LANDMARK COMMISSION

FILE NUMBER: COA-26-000034
LOCATION: 3712 Ruskin St.
STRUCTURE: Contributing
COUNCIL DISTRICT: 7
ZONING: PD-595

A Predesignation Certificate of Appropriateness to restore main building in fenestration, roof form/profile, and cladding -- correction of unauthorized work.

PROPOSED ROOF PLAN

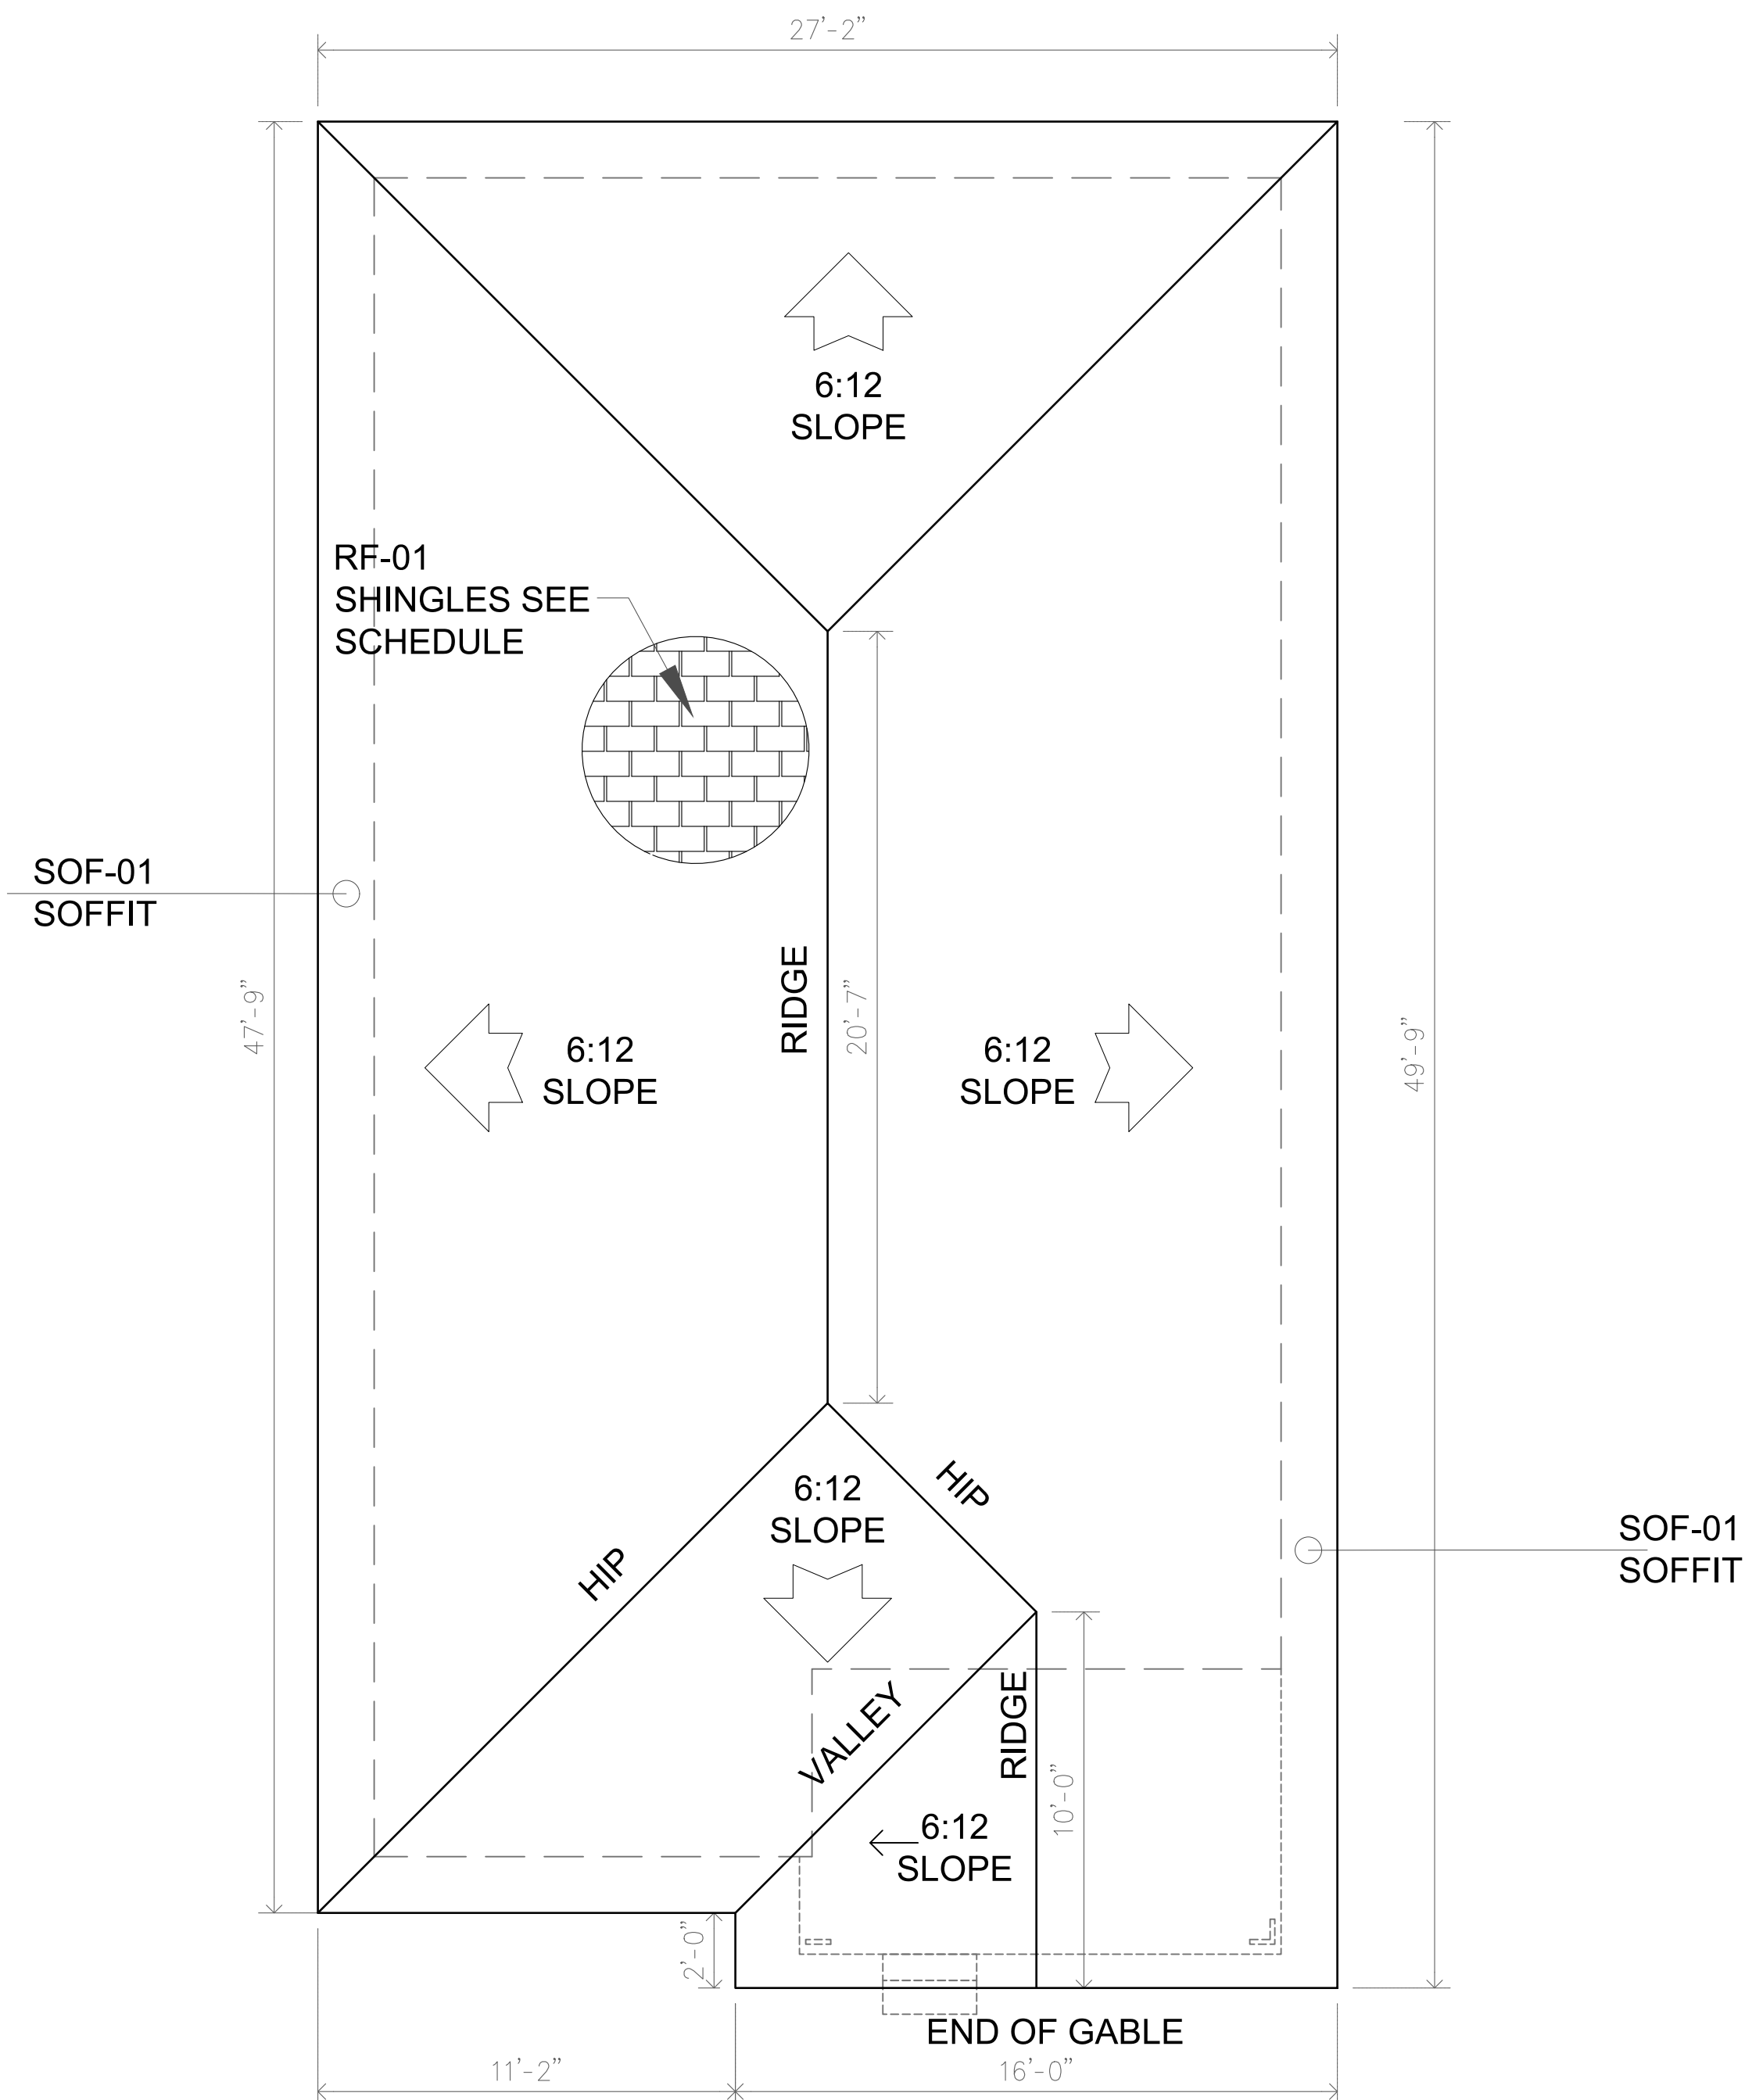
That the request to restore main building in fenestration, roof form/profile, and cladding -- correction of unauthorized work be approved in accordance with drawings and specifications dated 03/17/2026 with the following conditions: that pyramidal roof with exposed rafter tails and central masonry chimney stack be restored/reconstructed to the match the original in form, pitch, and detailing -- extended eaves and rafter tails matching in dimensions and number, and central masonry chimney matching in height, mortar color and replacement bricks (color, module size, and texture); that double asymmetrical front doors be restored to their original locations and opening dimensions; that all enclosed/infilled windows be reopened and resized to their original dimensions and locations; that all missing/removed wood trim and wood details (e.g., rafter tails) be replaced with in-kind materials matching in dimensions, composition, and profile; and that replacement siding be all wood horizontal lap-siding millwork pattern #117. Implementation of the recommended conditions would allow the proposed work to meet the standards in City Code Section 51A-4.501(d)(5)(A) for contributing structures, and the Secretary of the Interior's Standards for Rehabilitation.

A1.1 PROPOSED FRONT ELEVATION

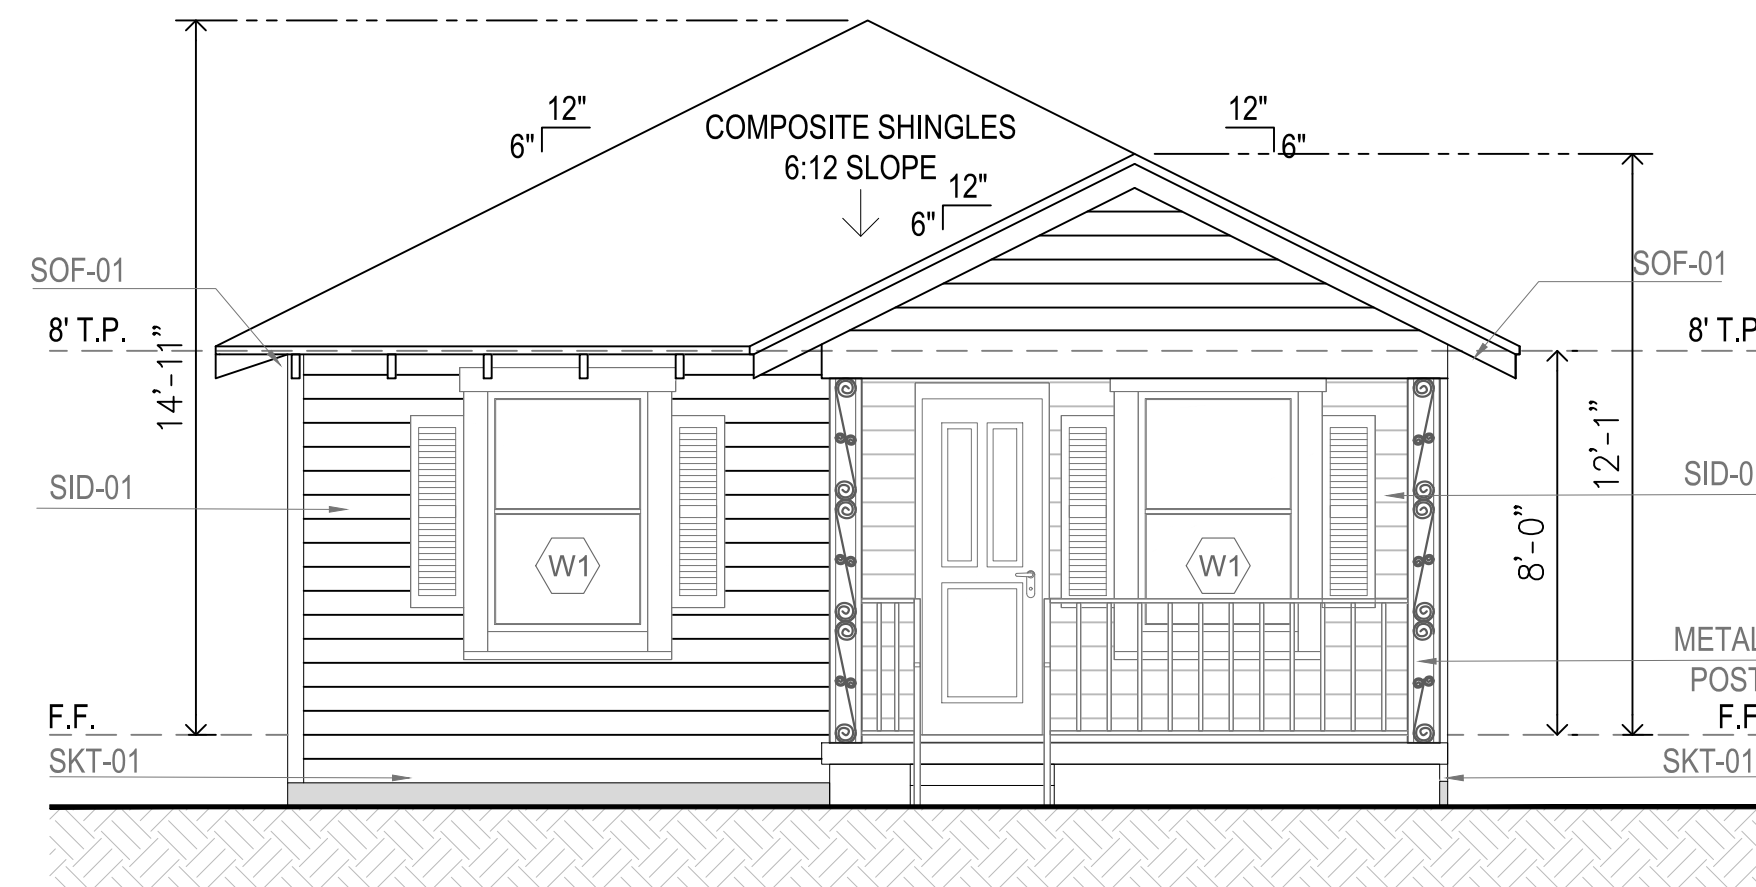
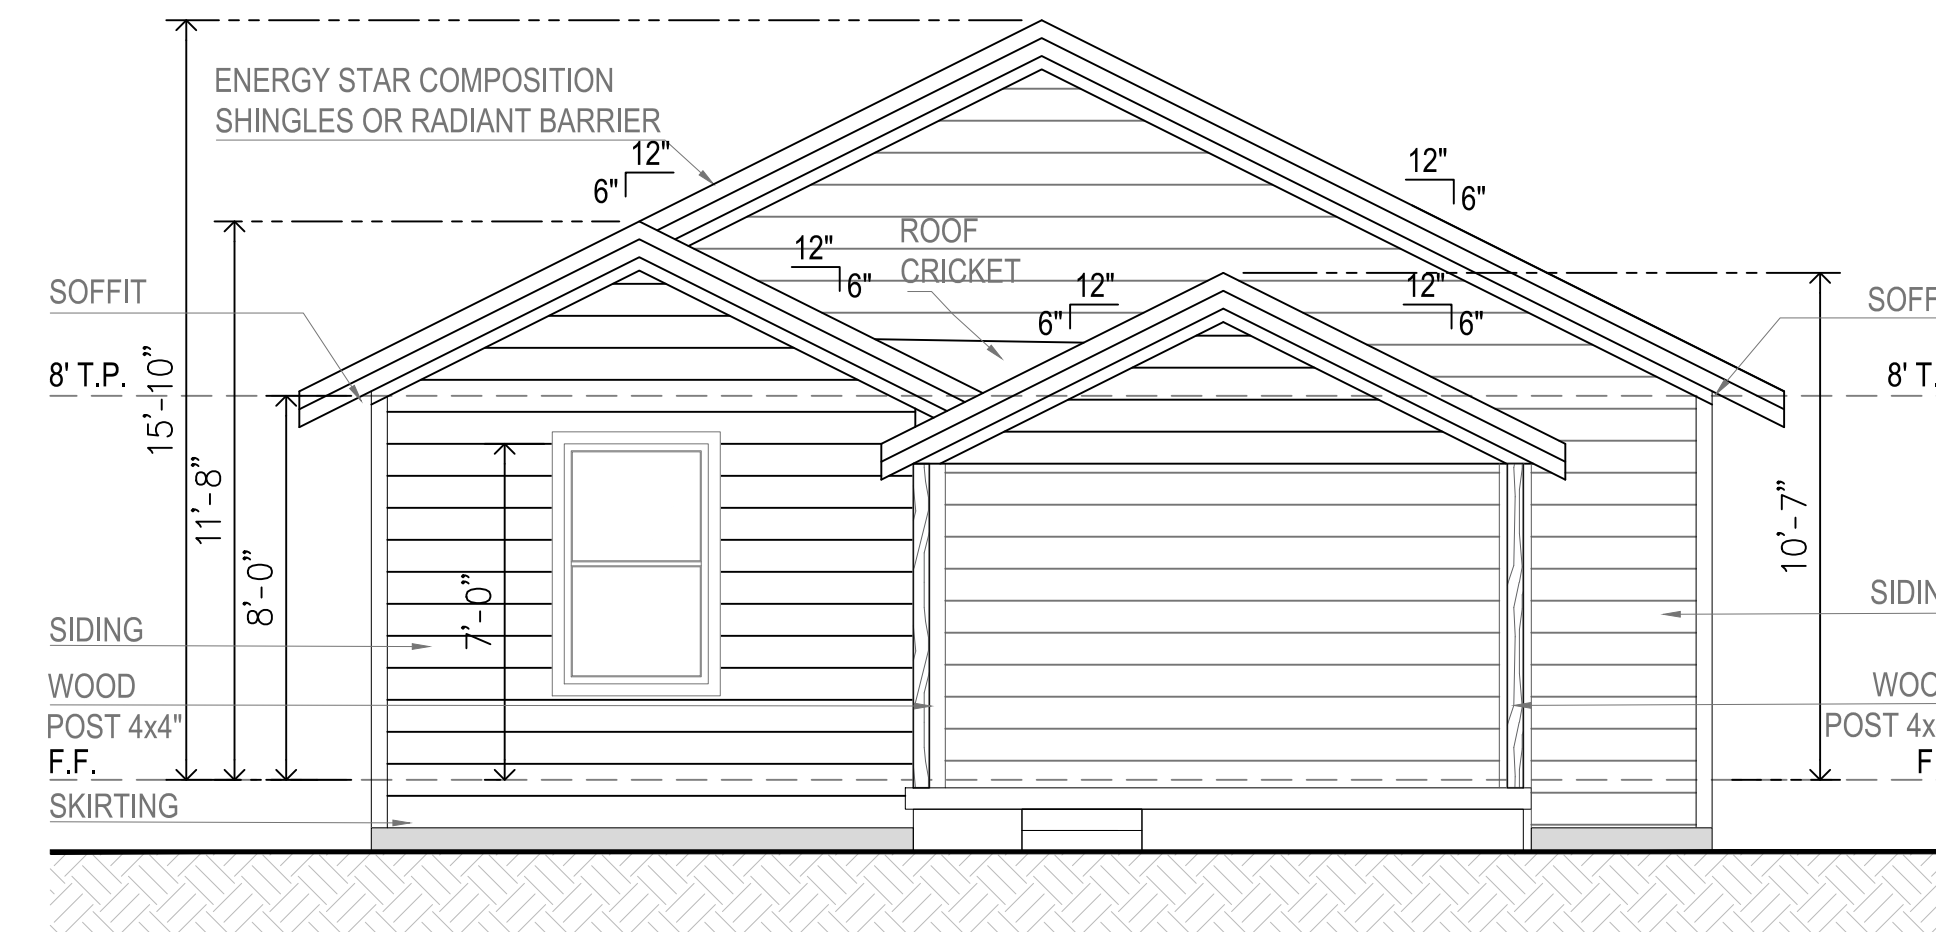
Restore to original structure, show side by side comparison, material used Add rafter tails & front doors trim open hang all original details
